ADDENDUM # 2

Project	Holy Family Catholic Elementary School	Project No.	2325
Location	1420 Grosvenor Street, Oakville, ON	Date of Issue	2024 04 05
Owner	Halton Catholic District School Board	File	2325/7.1.3

This Addendum forms part of the Contract Documents and amends the original Drawings and Specifications, dated 2024 03 26, and all preceding Addenda, as noted below.

ADDENDUM 01

GAS METER MODIFICATION SCHEMATIC

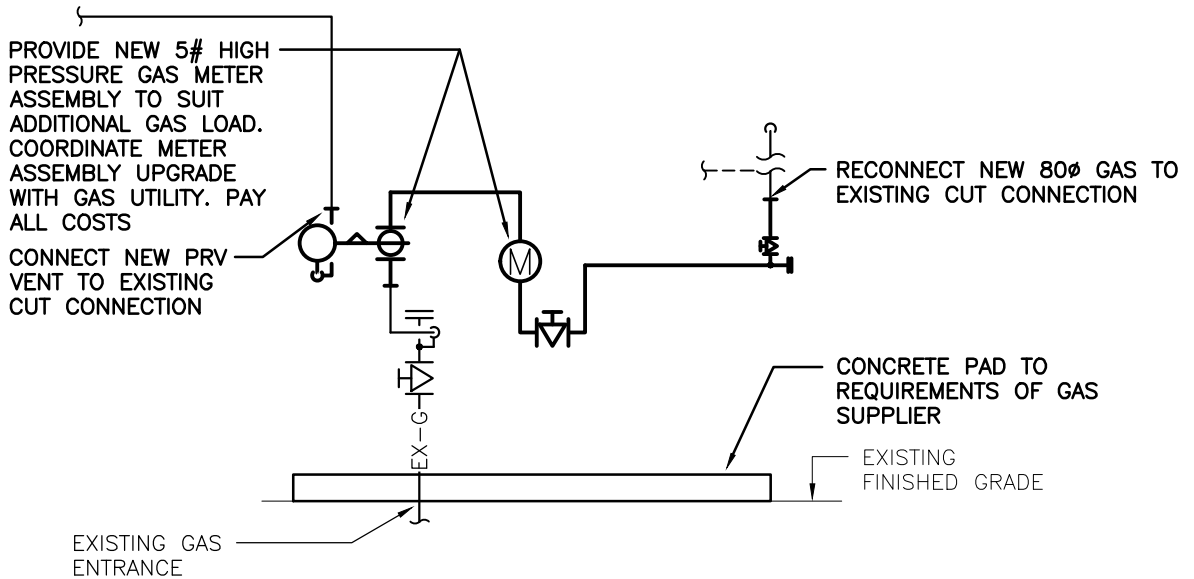
- 3.0 Reference Drawing M2.9 and Attached Sketch AD01-M03
- .1 Add gas meter modification detail.

NOTE:
 THIS CONTRACTOR TO CO-ORDINATE WITH LOCAL GAS COMPANY TO PROVIDE METER SUITABLE FOR ADDITIONAL CAPACITY OF ±2,860 cfh
